CITY OF FALLS CHURCH

SUBJECT: **SITE PLAN and SUBDIVISION 20090057 - 6607 Wilson Boulevard, BJ's Wholesale Club**

SIMULATED VIEW FROM THE BACK OF THE BUILDING
RESIDENCE AT 932 N. GUESADA ST.

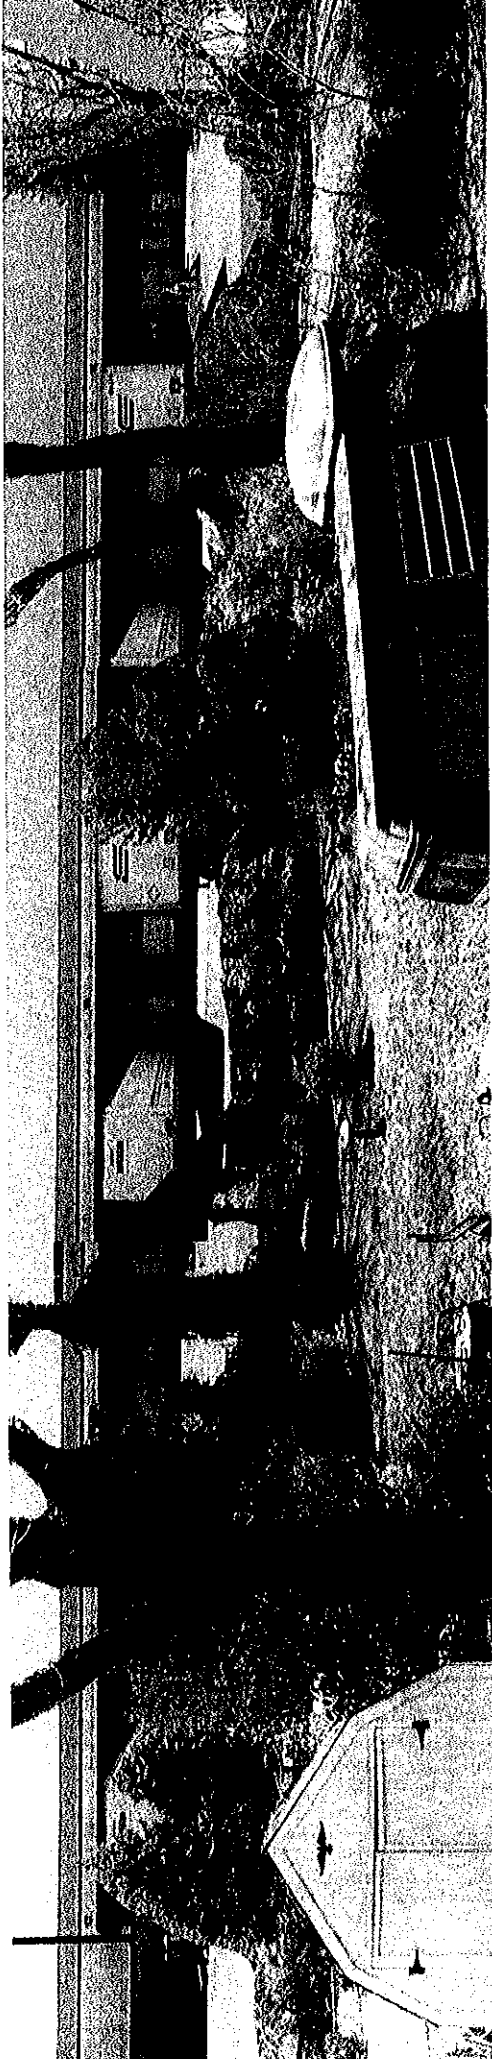
To illustrate the visual impact of the development, we are enclosing a composite photograph which depicts the anticipated view from the back door of our house as described to us by the developer. They proposed to clear cut all trees and vegetation from the 30' buffer zone that runs along the back of our lot. Some of the trees that they will cut down have a girth of 5 to 6 ft, and are probably hundreds of years old. The buffer zone provides an excellent buffer screen as it sits right now. We therefore ask that the plan to clear-cut the 30' buffer zone be rejected, and that buffer zone be left in an "as-is" condition. This area acts as a preferred wildlife habitat and should not be destroyed.

The second objection we have is that in order to screen the adjacent residential properties from the noise and lights of delivery trucks, (which apparently will drive all the way around the perimeter of the BJ property at all times of the night,) a solid wall of perhaps 10 to 12 feet in height ought to be constructed along the northern limit of their parking lots and the northern section of the truck driveway.

A third concern that we have is the risk of storm water flooding that may flow from their property onto ours. This could be mitigated by constructing an 8" curb along the northern limit of the parking spaces and the truck driveway and ensuring that all surface runoff is collected and directed into the storm sewers.
